NO.	SCOPE OF WORKS	REMARKS
1	INSTALLATION OF METAL SUPPORTS OR CABLE TRAY FOR PLANT 2- PHASE A, PLANT 3- PHASE A & PHASE C, PLANT 4- PHASE C	AS PER RECOMMENDATION OF WESTCO, CORRECTIVE ACTION (FEB 2024) UPON PMS FINDINGS (CONDUCTED BY FUJI HAYA OCT 2023)
2	REPLACEMENT OF CRACKED BUSHING FOR PLANT 3- PHASE A (X1)	AS PER RECOMMENDATION OF WESTCO, CORRECTIVE ACTION (FEB 2024) UPON PMS FINDINGS (CONDUCTED BY FUJI HAYA OCT 2023)

Findings and Observation

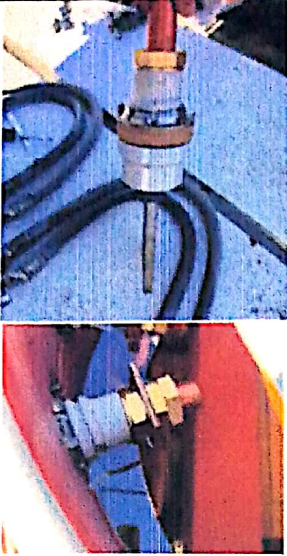
<p>Findings: Oil contaminants were found in the following transformers: Plant 1 Phase A, and C, Plant 2 Phase A, B, and C, Plant 3 Phase B, and Plant 4 Phase C.</p> <p>Action Taken: Oil flushing was performed before the replacement of transformer oil to eliminate the contaminants.</p>
	<p>Findings: Oil leakage was observed after disconnecting secondary terminals of the transformer. This could be due to the stress caused by the weight of the metal plates and cables.</p> <p>Action Taken: Regasketing was also performed in the secondary bushing of the transformer.</p> <p>For Plant 2 - Phase A, Plant 3 - Phase A & Phase C, Plant 4 - Phase C</p> <p>Recommendation: Installation of metal supports, or cable trays is recommended to support the weight of metal plates and cables.</p> <p><i>See image below for the initial proposed installation layout</i></p>
